**Proposed Minor Relaxation of Building Height Restriction for Permitted Flat Use
Tung Chung Town Lot 49, Tung Chung Road North, Lantau Island
(Section 16 Planning Application No. A/I-TCTC/71)**

- Further Information No. 2 -

**Proposed Minor Relaxation of Building Height Restriction for Permitted Flat Use,
Tung Chung Town Lot 49, Tung Chung Road North, Lantau Island
(Section 16 Planning Application No. A/I-TCTC/71)**

Figure: 4.6

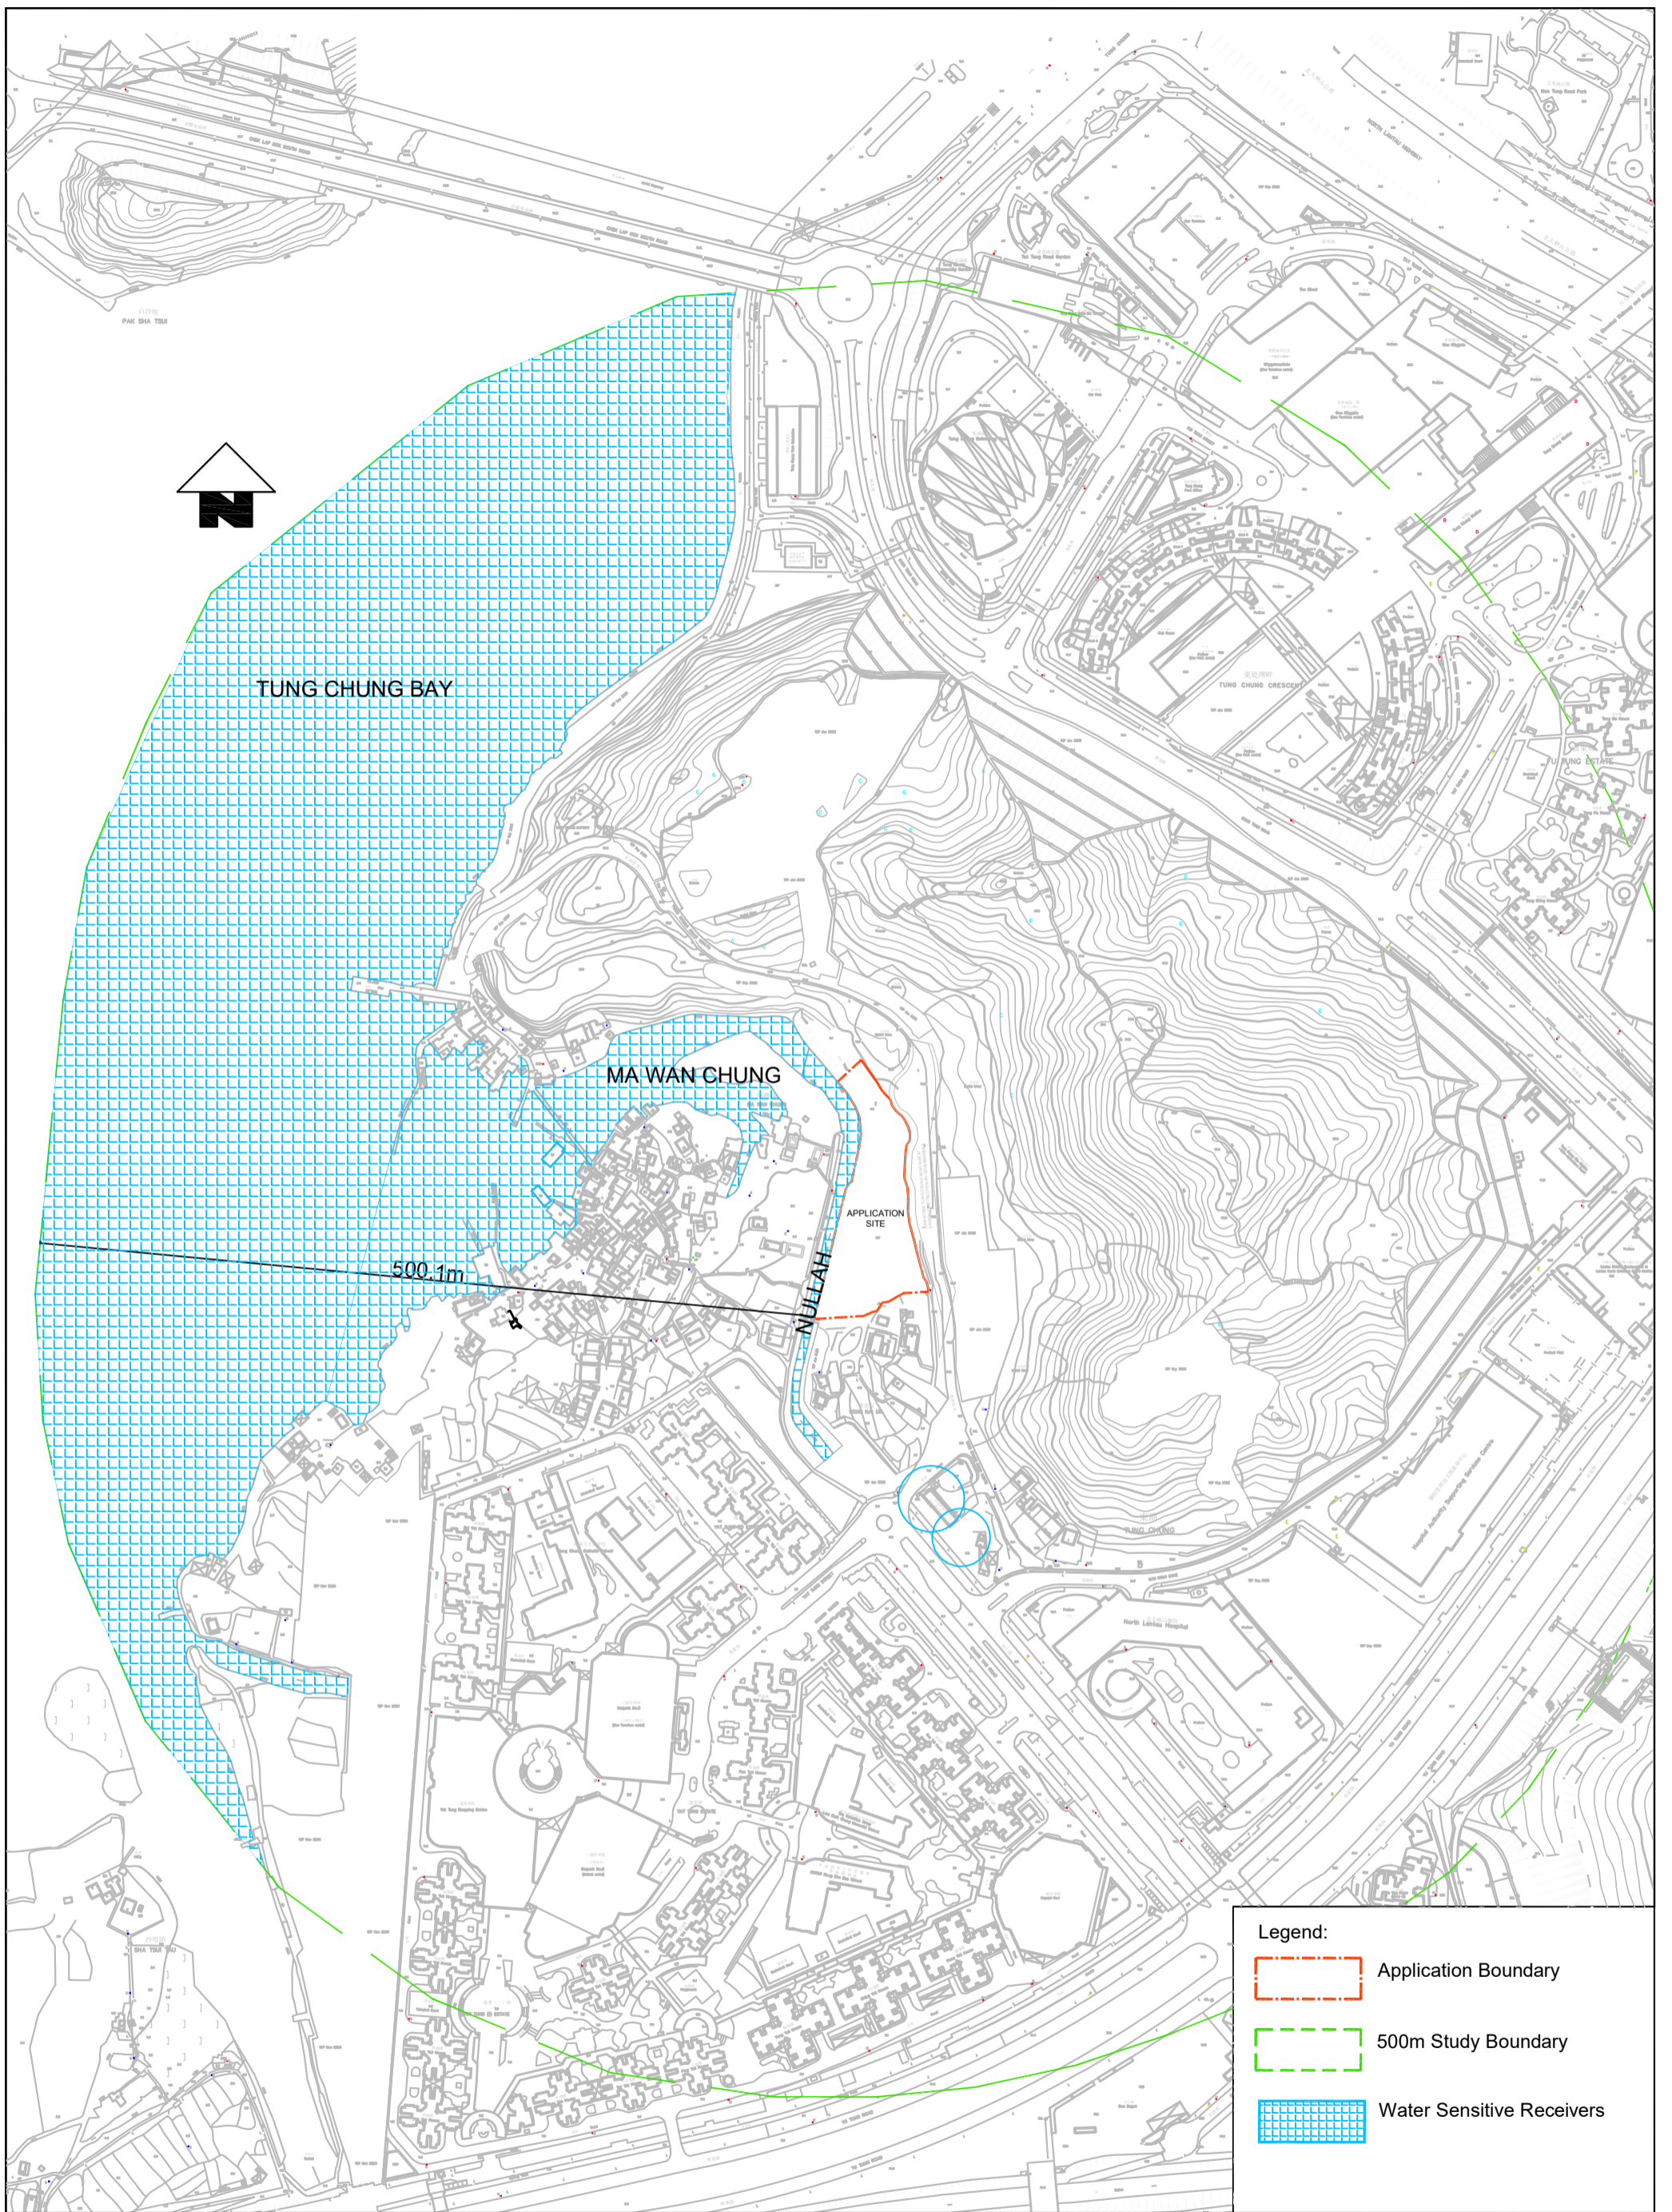
3.16	Figure 4.6 – Please rectify typo “31 October 2025” in the legend.	Noted and Figure 4.6 of the EA has been updated accordingly.
	Noise	
3.17	Re. S 1.4.6, the aircraft noise criterion for domestic premises is NEF25 as per HKPSG. Please revise.	Noted. S.1.4.6 of the EA has been revised accordingly.

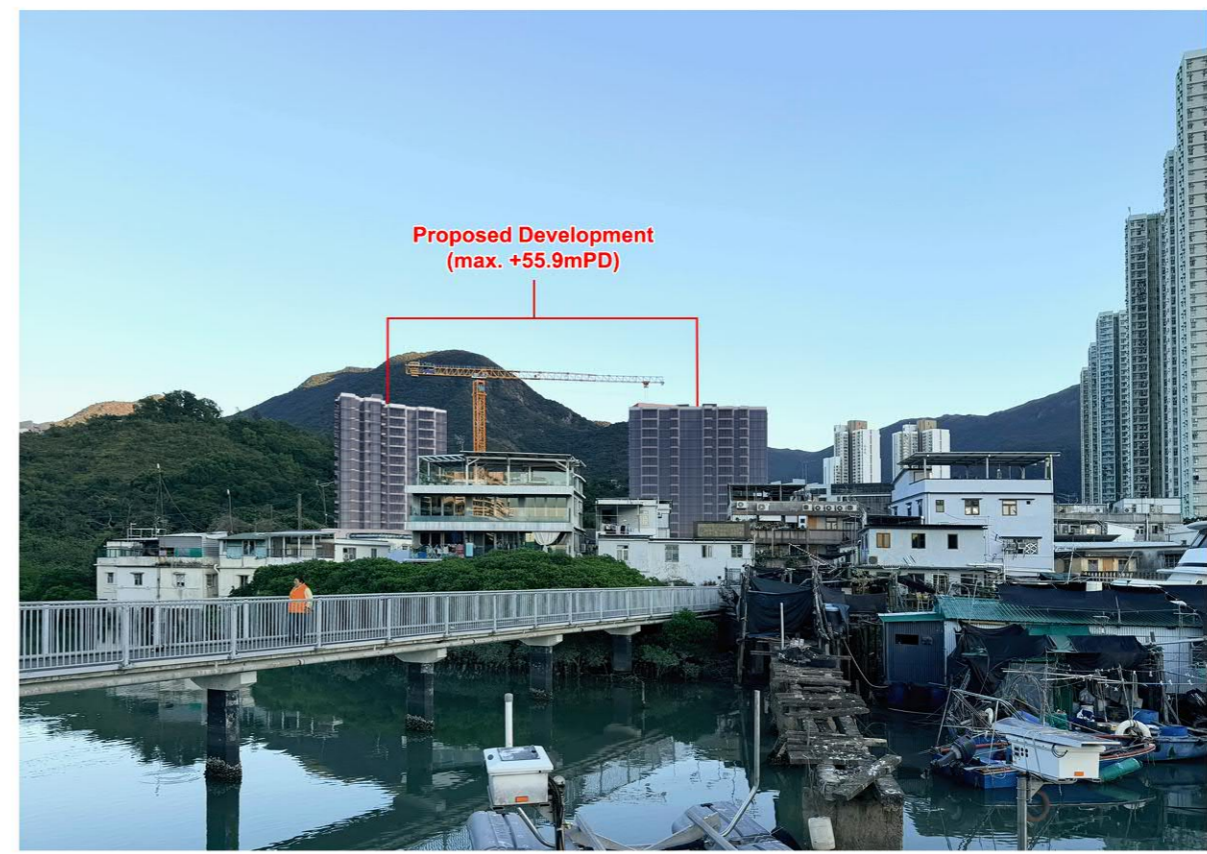
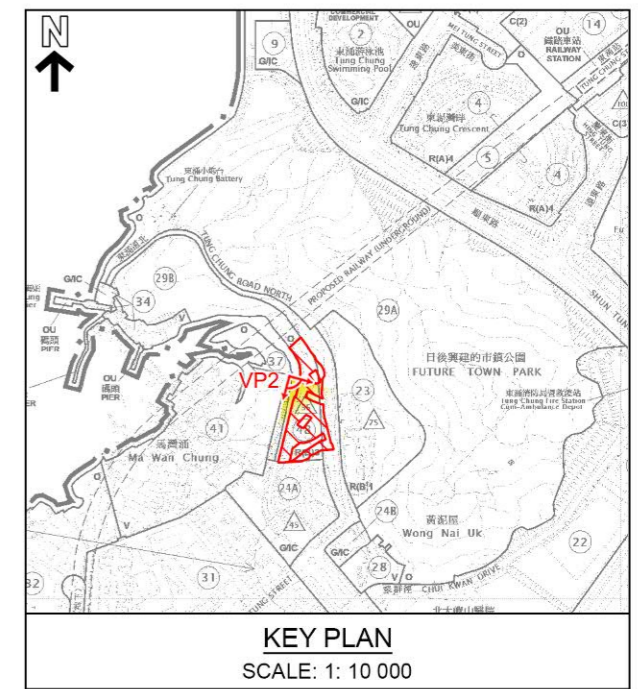
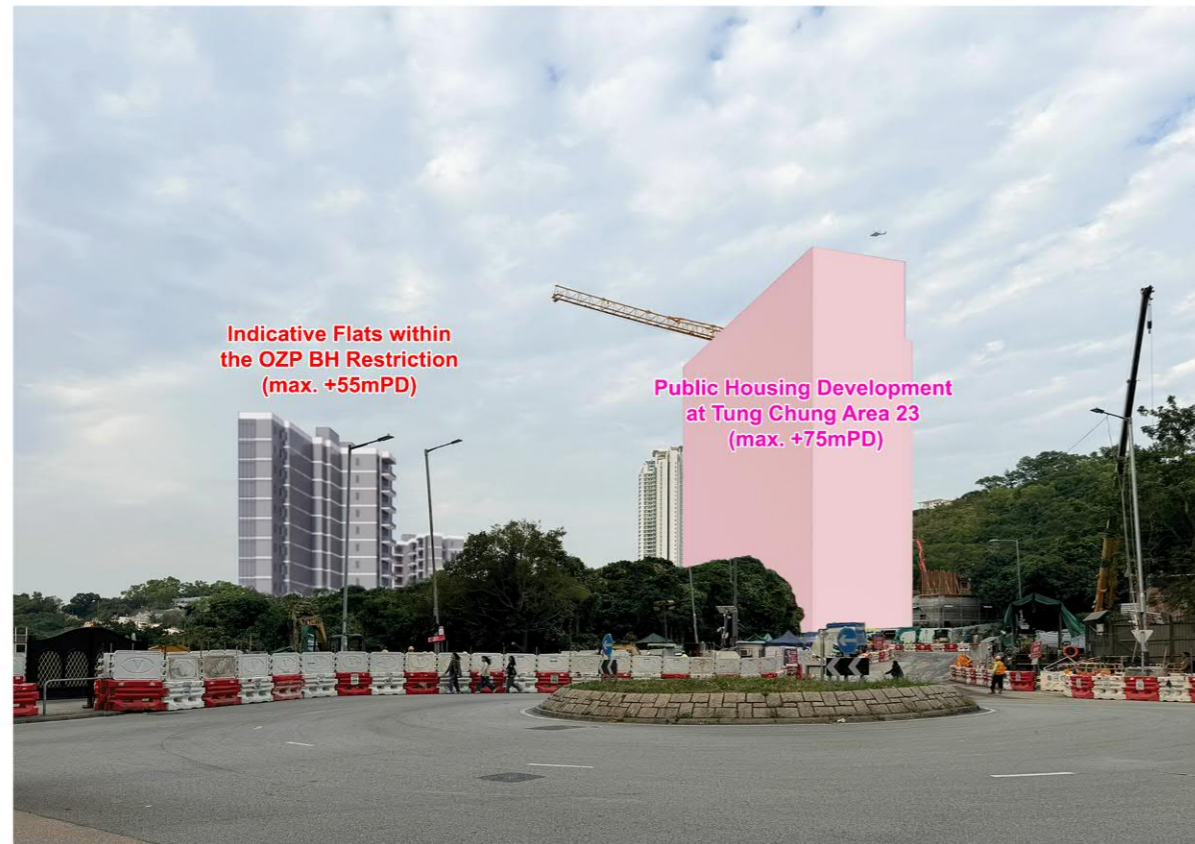
5.1	VA – discussion of the magnitude of change should be discussed in the VA as stated in Appendix C of the TPB-PG No. 41A	Noted.
5.2	VA – given the proposed BHR has been revised to 55.9mPD, the consultant please review whether the photomontages of VP1, VP2	The photomontages of VP1, VP2 and VP3 of the Visual Appraisal (Annex G refers) are revised.
